From: Neil Duffield
Sent: 09 April 2020 11:41
To: Helen Webster
Subject: NYM/2019/0795/LB - Downhill Cottage, New Road, Robin Hoods Bay E11726- NYMNP
Section drgs 09-04-20

CLIENT: **Mr J Kingham**
 PROJECT: **Refurb of Downhill Cottage New Road, Robin Hoods Bay**

DRAWING STATUS: Preliminary	
DRAWN: C Eynon	CHECKED: N I Duffield
SCALE @ SIZE: 1:50@ A1	DATE: 11/11/19
DRAWING No: D11726-02	REV: D

DRAWING TITLE: Proposed Floor construction	
DRAWING NR: D11726-05	REV: A

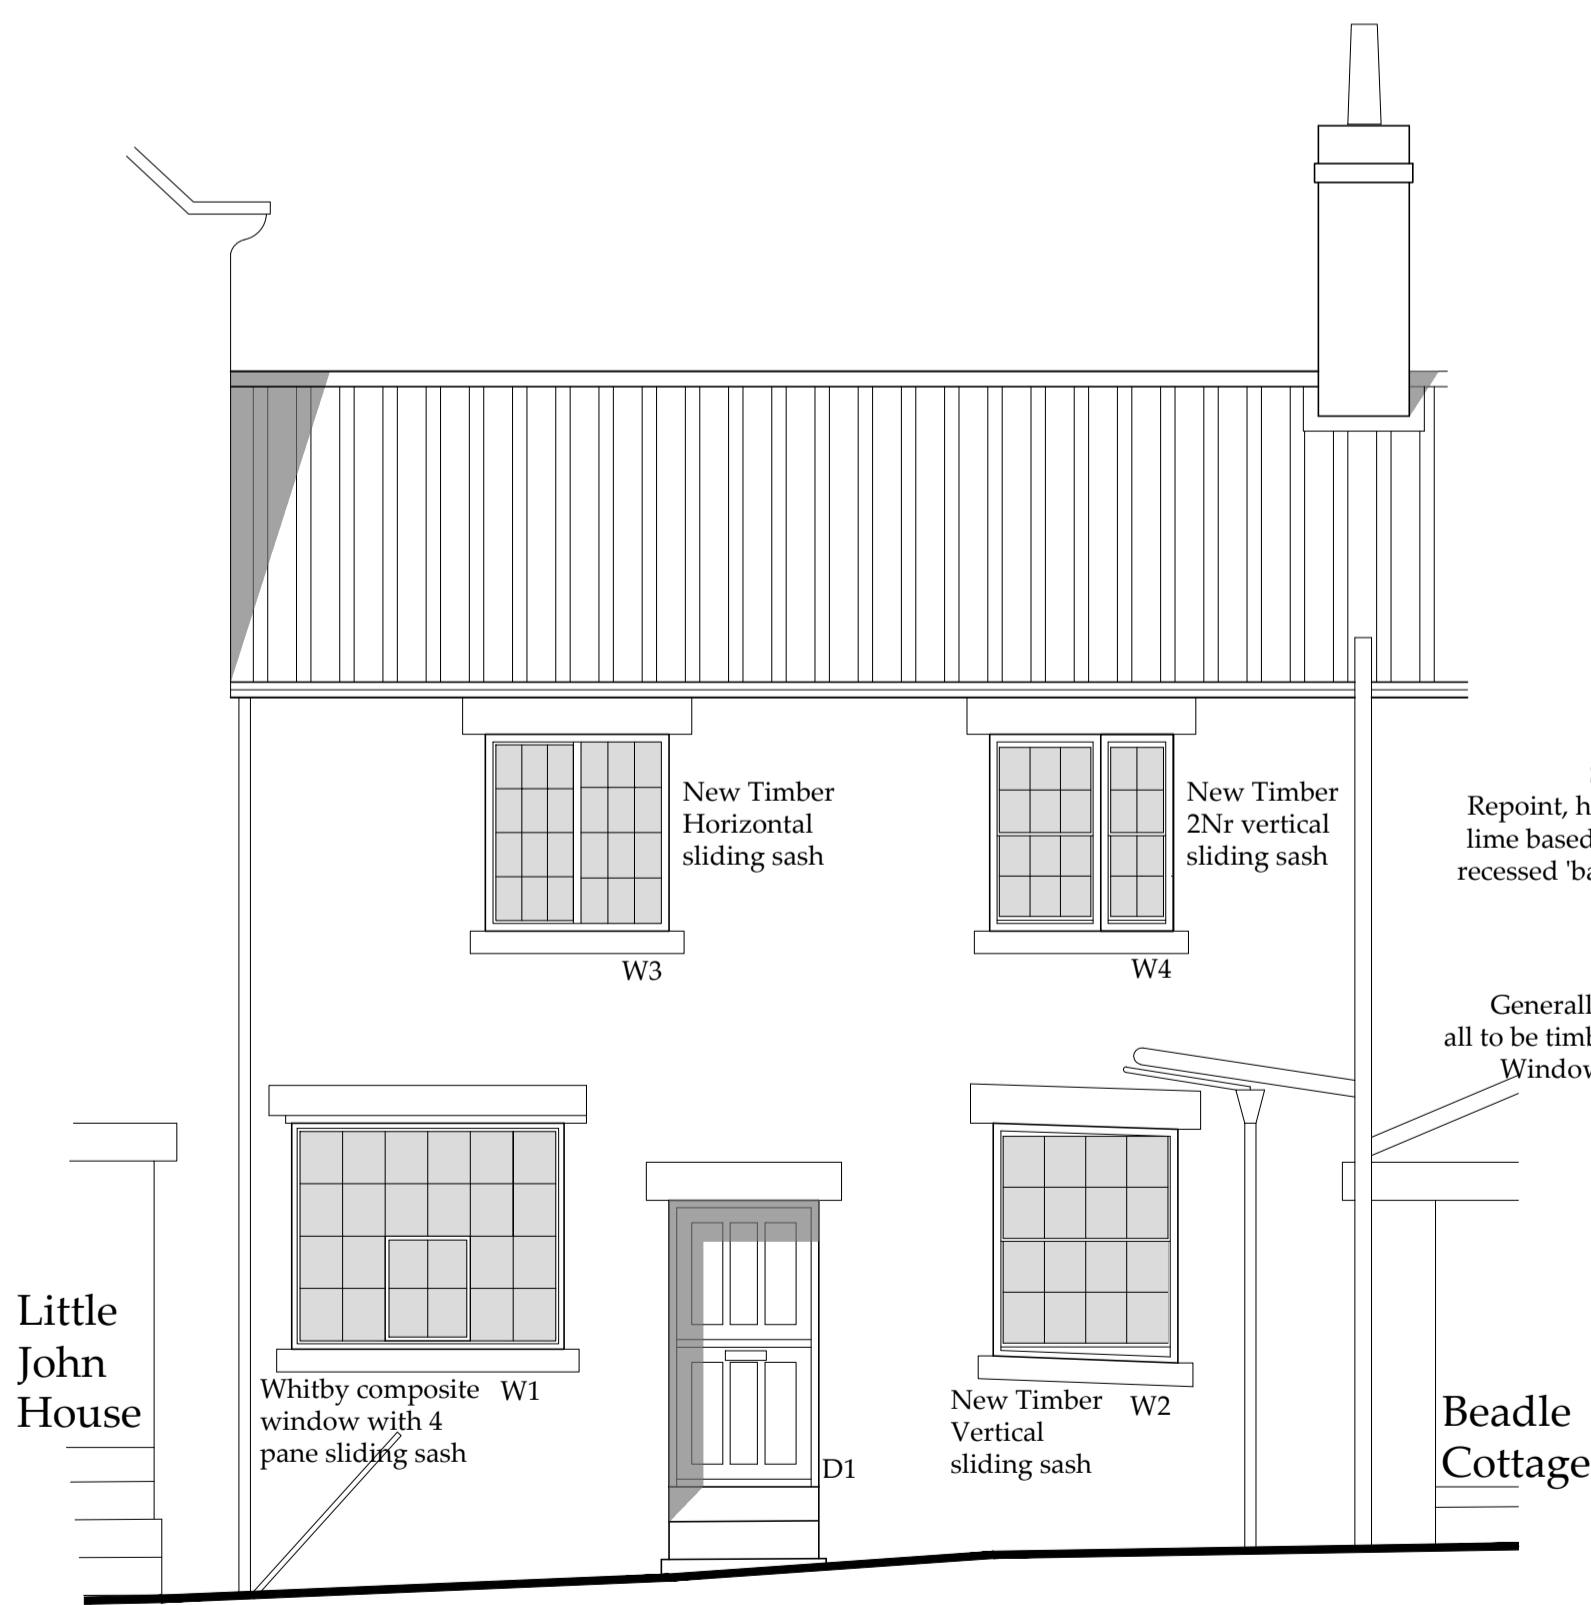
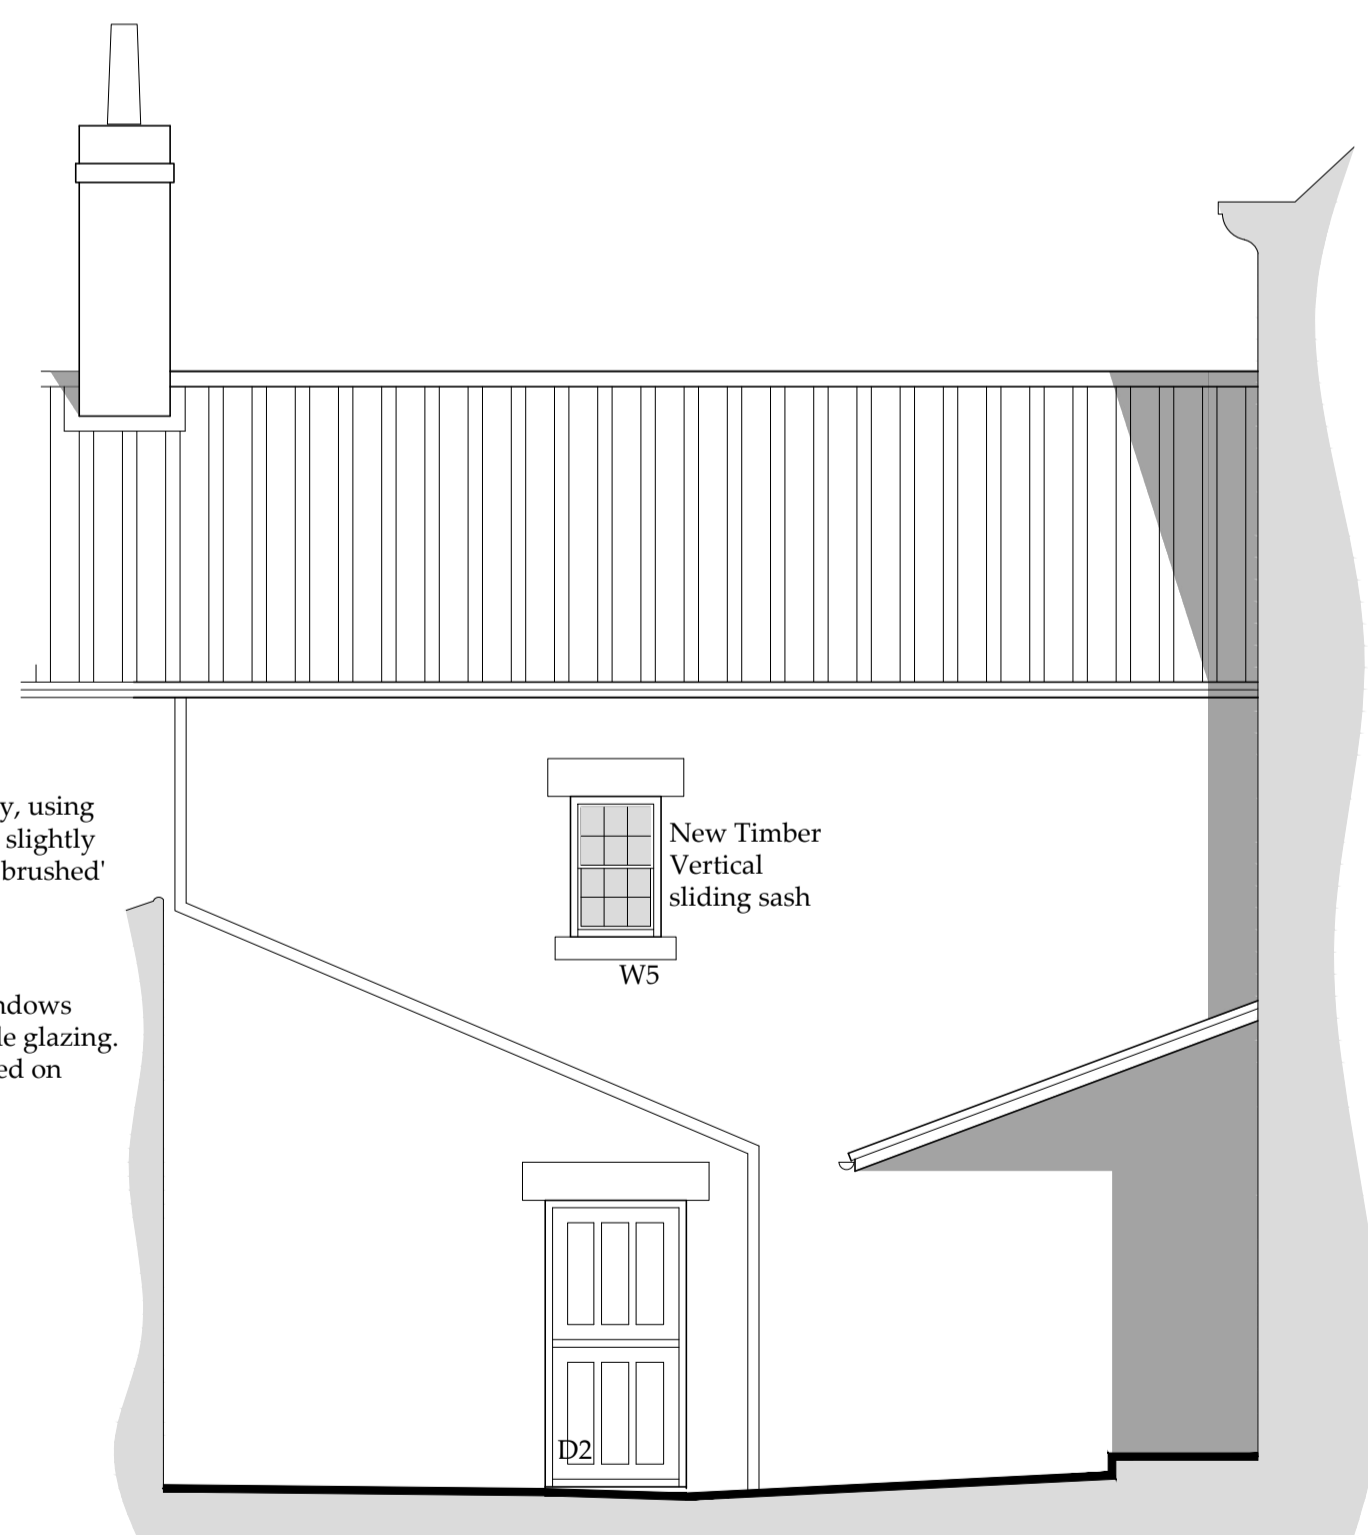
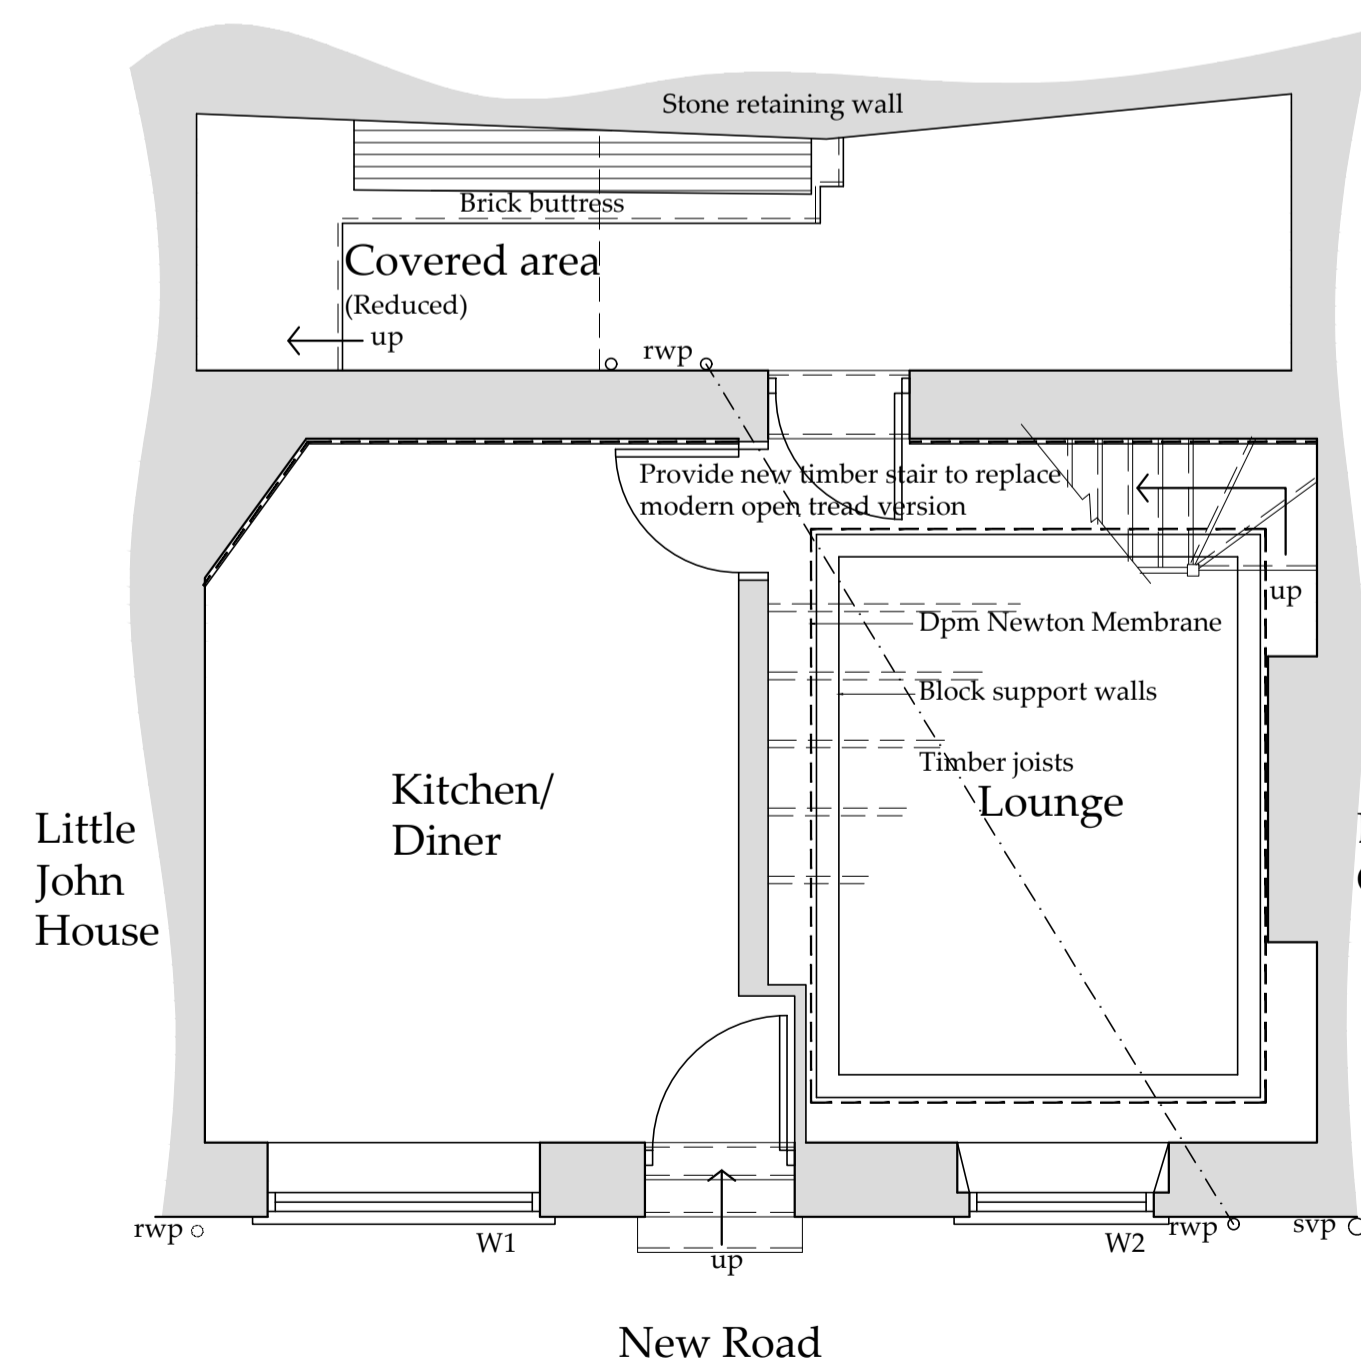
I have finished the section drawings for the new floor construction and drawing D11726-05A is attached along with the drawing D11726-02D the Proposed Plans and elevations with the Sauna removed.

REV	DATE	BY	AMENDMENT
D	02/04/20	nid	Sauna Removed
C	24/02/20	CE	Sauna amended
B	04/02/20	CE	W1, all glazing and sauna.
A	11/11/19	CE	Issued for approval

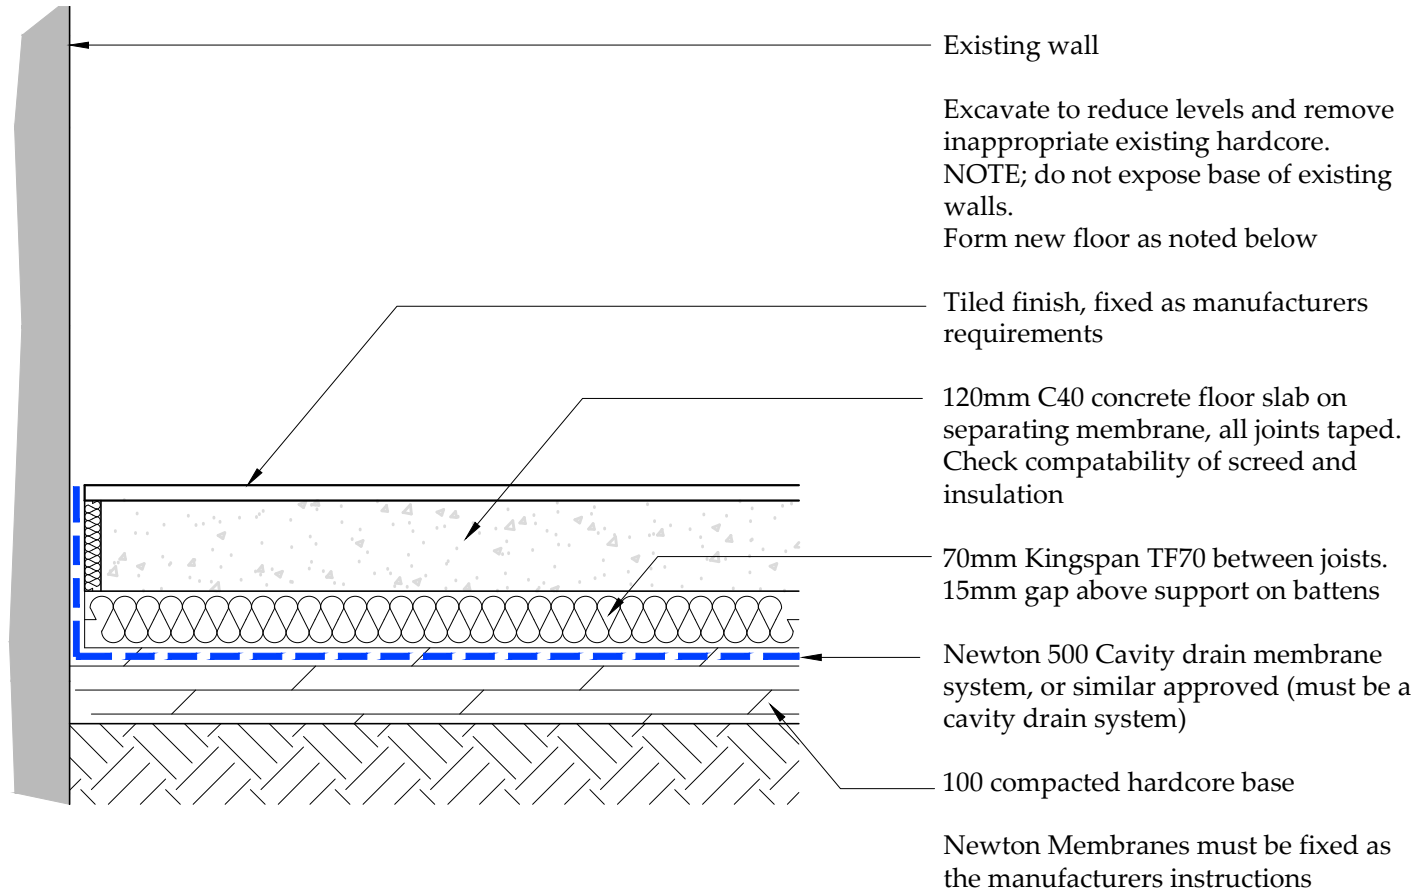
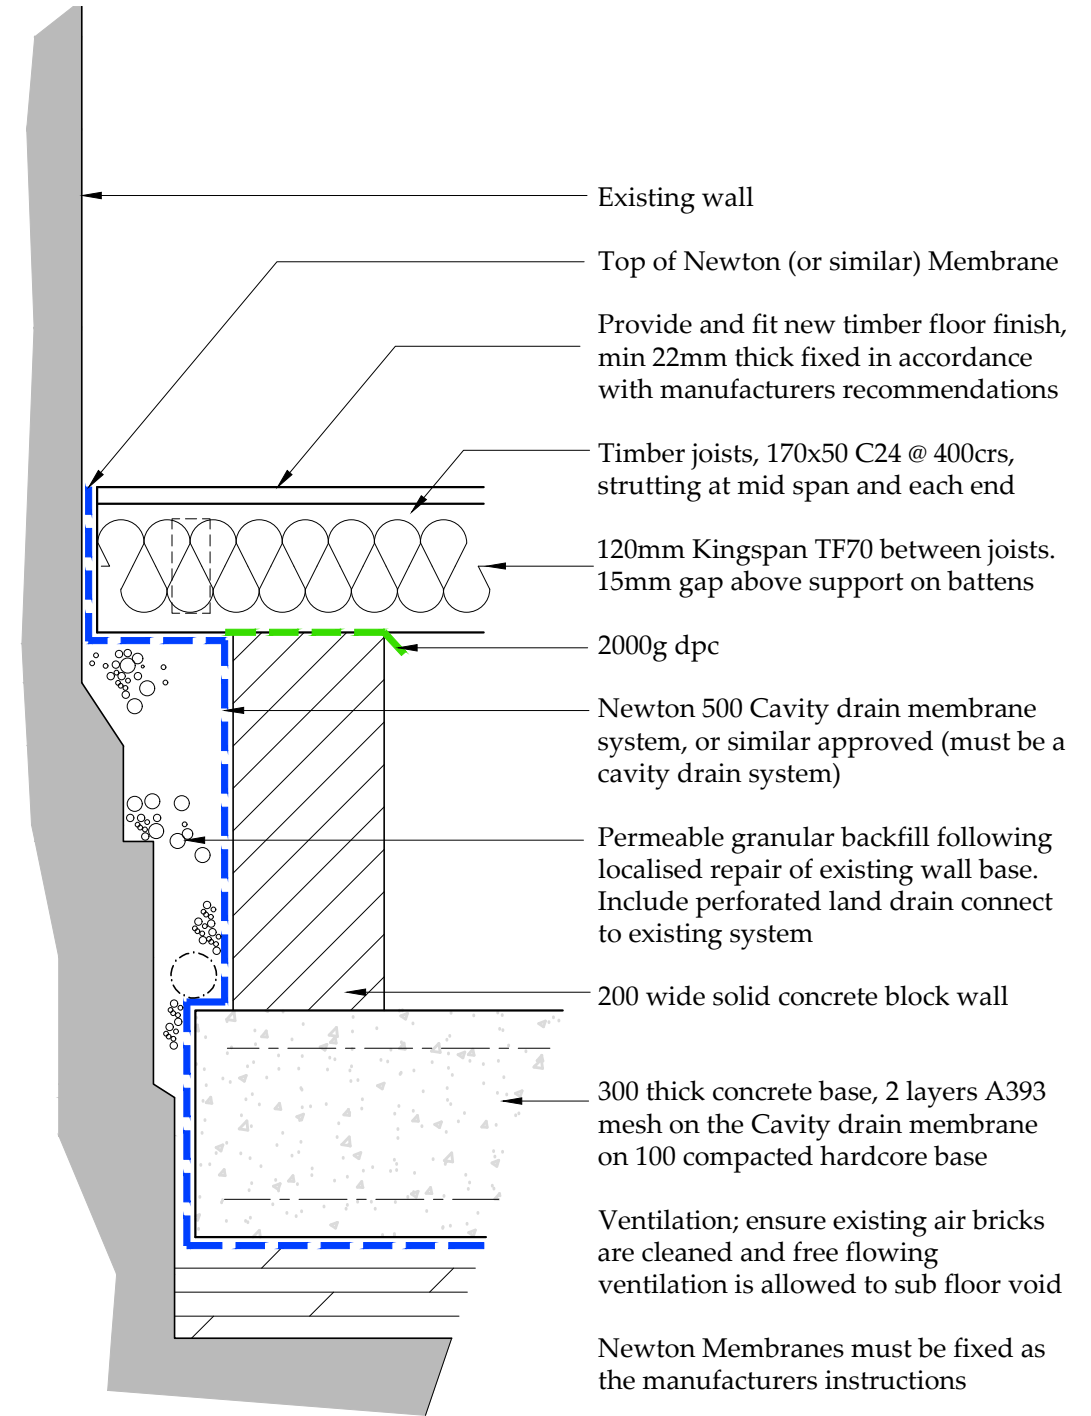
In terms of not negatively affecting the moisture levels in the existing structure we have included a 'cavity drain membrane'.

The Newton Cavity drain Membrane is one of a variety of damp proof membranes designed to allow percolation of moisture in existing structures to remain unaffected while preventing the moisture from reaching the new construction. The following link takes you to the product.
